Submission to Sydney Olympic Park Master Plan 2030 (2016 Review)

On behalf of The GPT Group

15 November 2016

Figure20: Amendment to Central Precinct building height plan

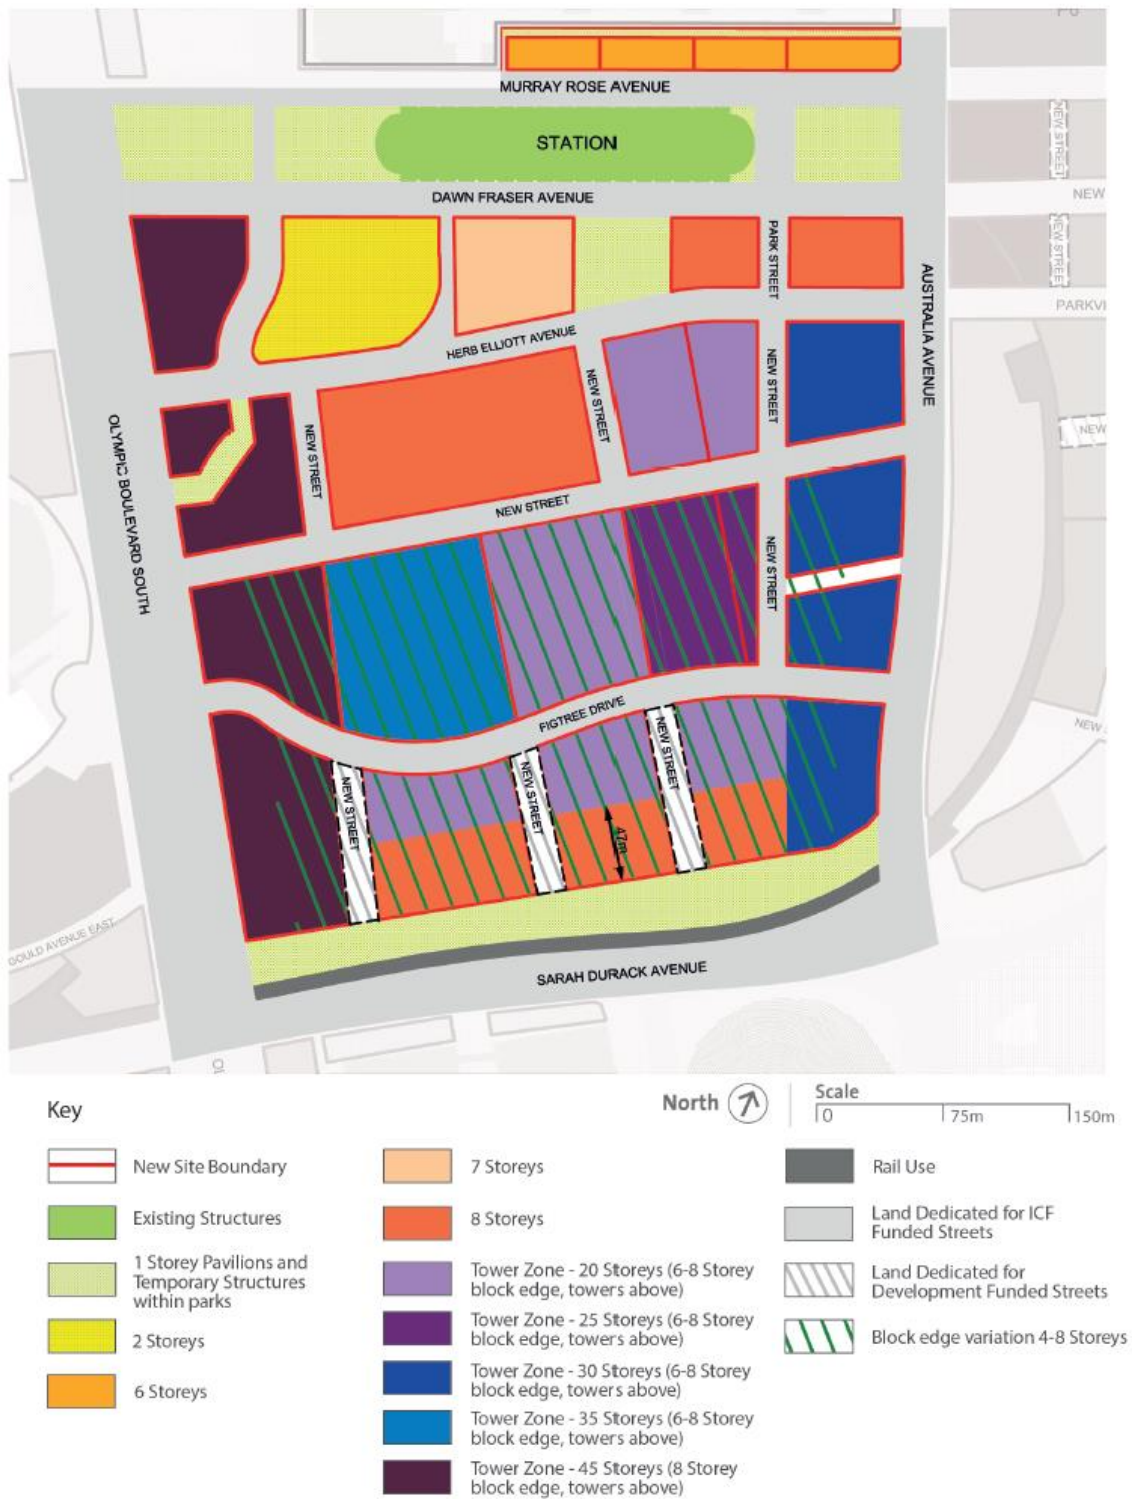
Having regard to the above it is recommended that the 4-8 storey variable street wall height be extended to the new main street as illustrated in Figure 20.

- Amend the building heights maps in section 5.2 of the Master Plan to indicate 25 and 35 storey buildings as illustrated in Figure 20.
- Amend the SEPP Building Height Map as illustrated in Figure 21 to increase the buildings heights from 74m to 90m and 102m to allow for the 25 storey and 35 storey height variation in the centre of the precinct.
